Subject: New England Power Company
N12/M13 Double Circuit Tower Separation Project
Expanded Environmental Notification Form
Somerset and Fall River, Massachusetts

Appendix E-2: Remote Consultation with Environmental Analyst Response Letter

Subject: EEA No. 16467
New England Power Company
N12/M13 Double Circuit Tower Separation Project
Expanded Environmental Notification Form
Somerset and Fall River, Massachusetts

M13 and N12 115kV Line DCT Separation
 PROPOSED PROJECT
 CONSTRUCTION FEATURES

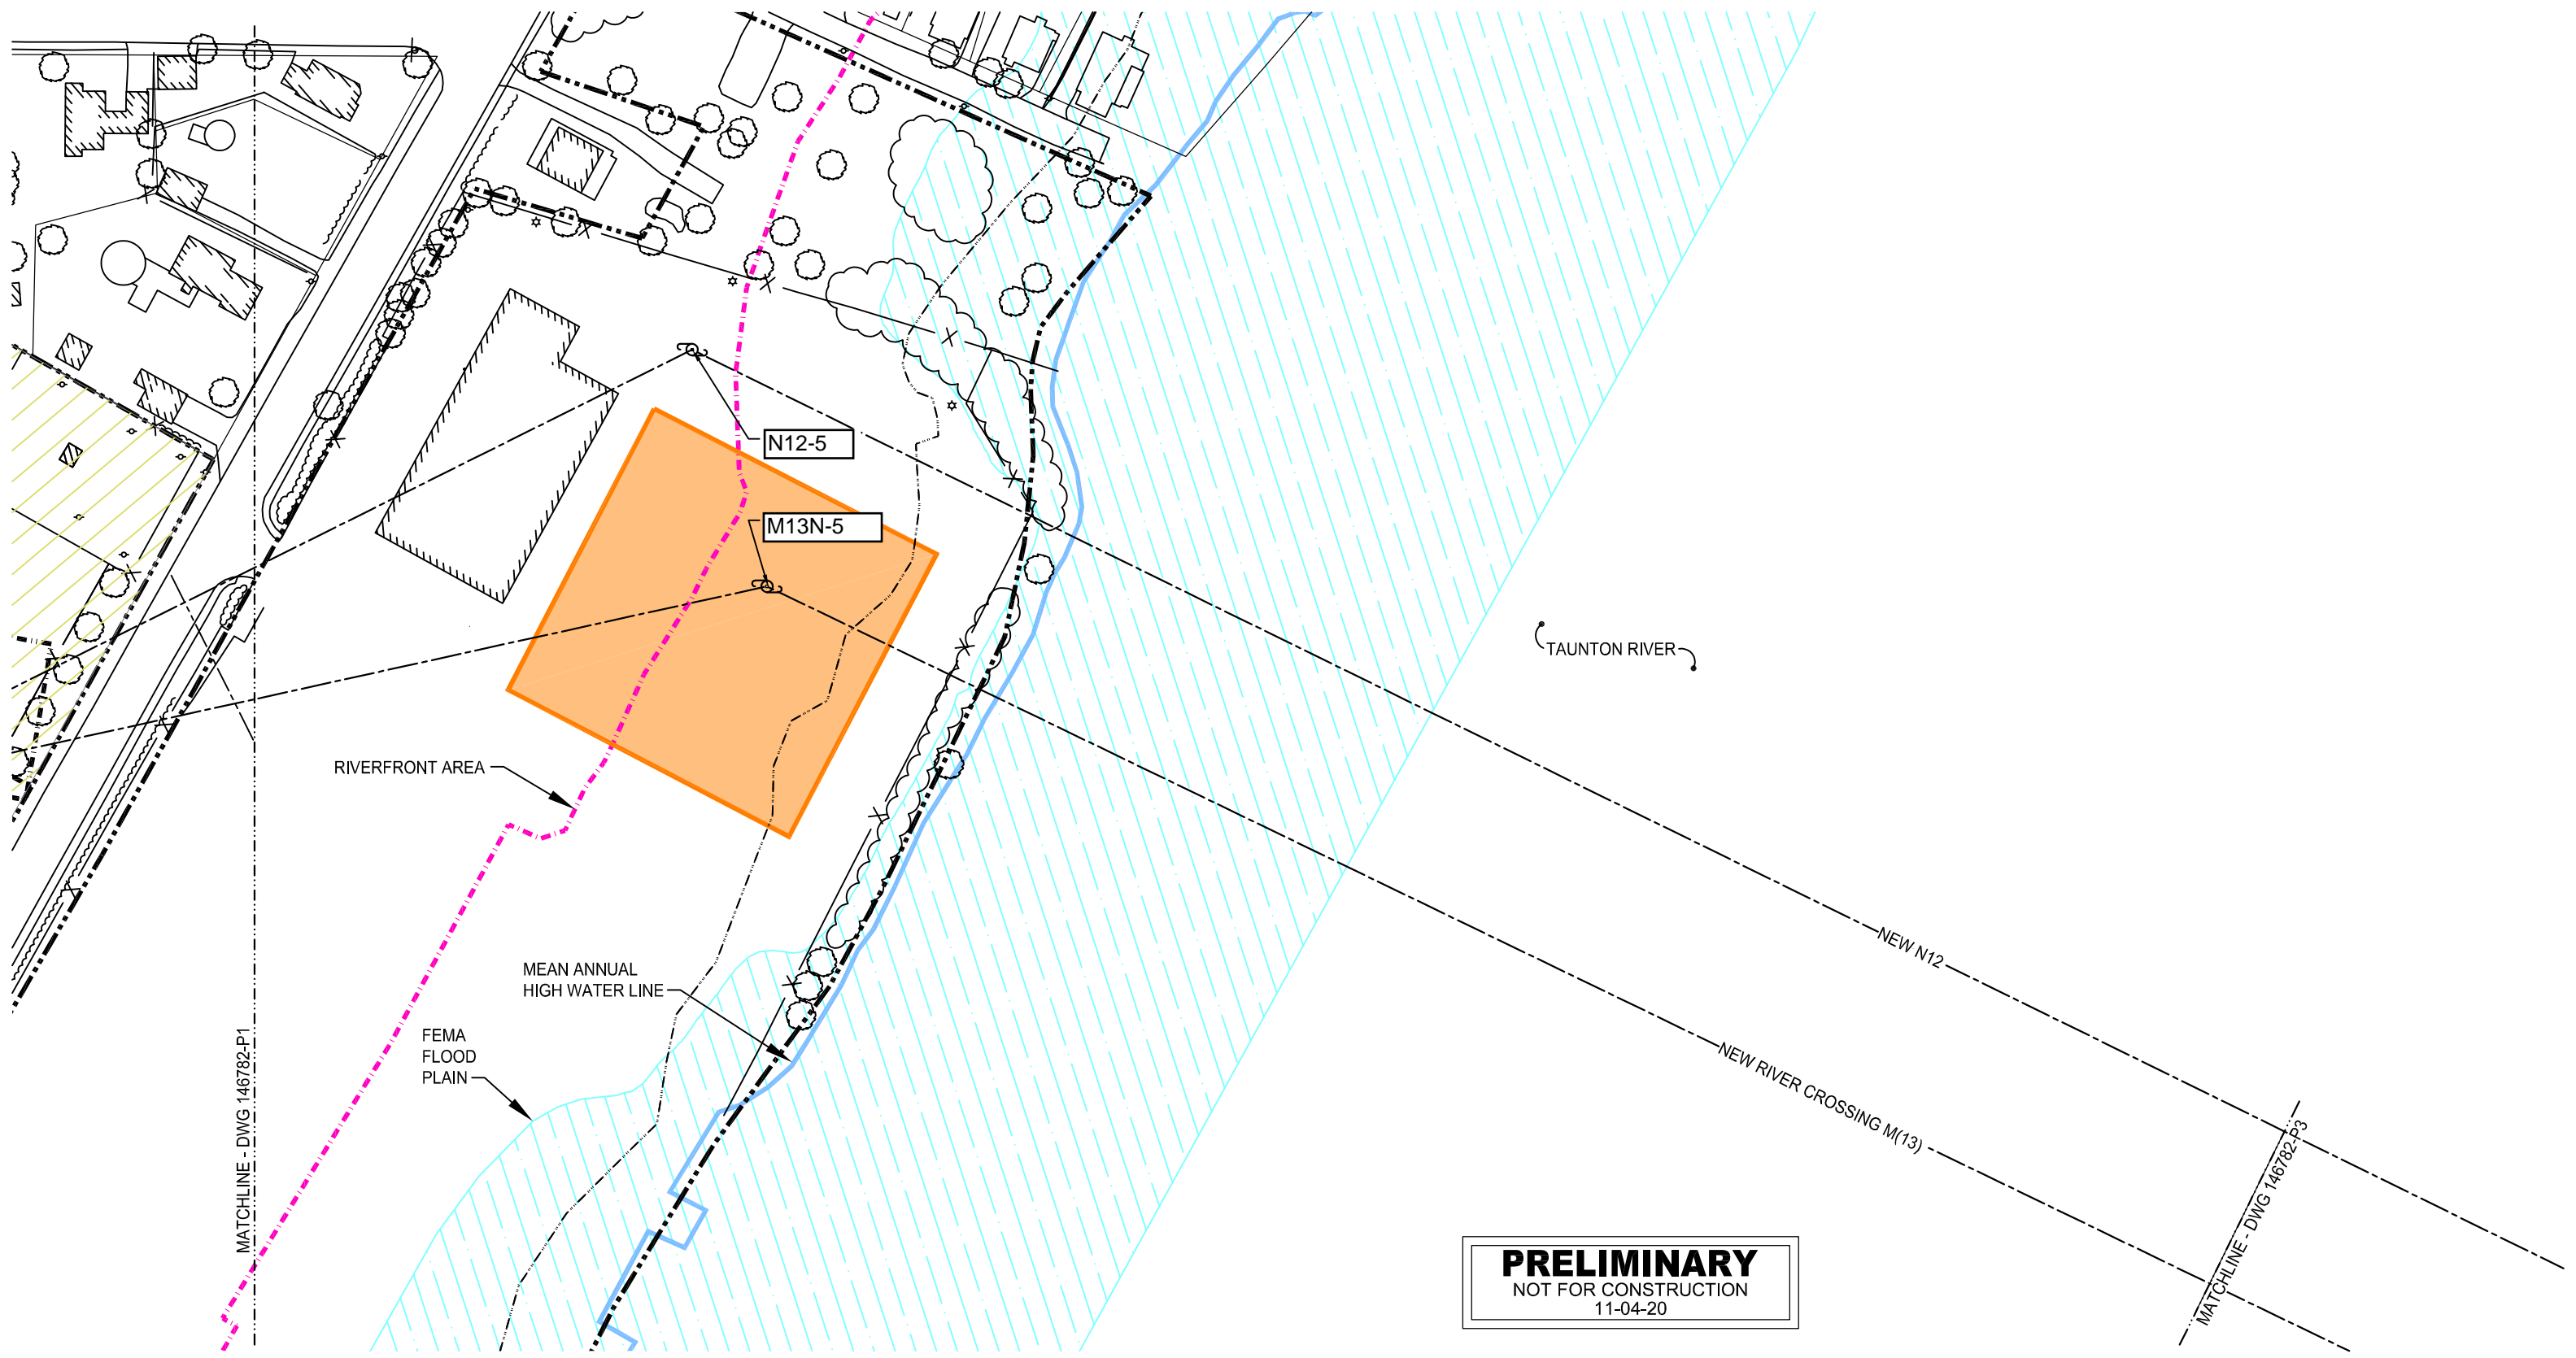
Question/Request: A zoomed in plan with delineated coastal resource areas (VE Zones) for the two locations where the river-crossing towers will be located.

NEP Response: Attached are two sets of figures. The first set of figures are preliminary grading plans prepared for the proposed construction within Land Subject to Coastal Storm Flowage to install proposed structure M13N-6. The grading plan includes an access route, structure work pad and accommodates for construction staging and construction storm water BMPs. No grading is required for M13N-5. Construction and staging of equipment for M13N-5 will take place on existing asphalt on the east side of the Taunton River. The second set of figures are excerpted from the Project Wetland and Stream Report to illustrate the coastal resource areas and VE zones found on the Somerset and Fall River sides of the Taunton River. Representative photographs of the wetland resource areas are found within the report appended to the ENF filing.
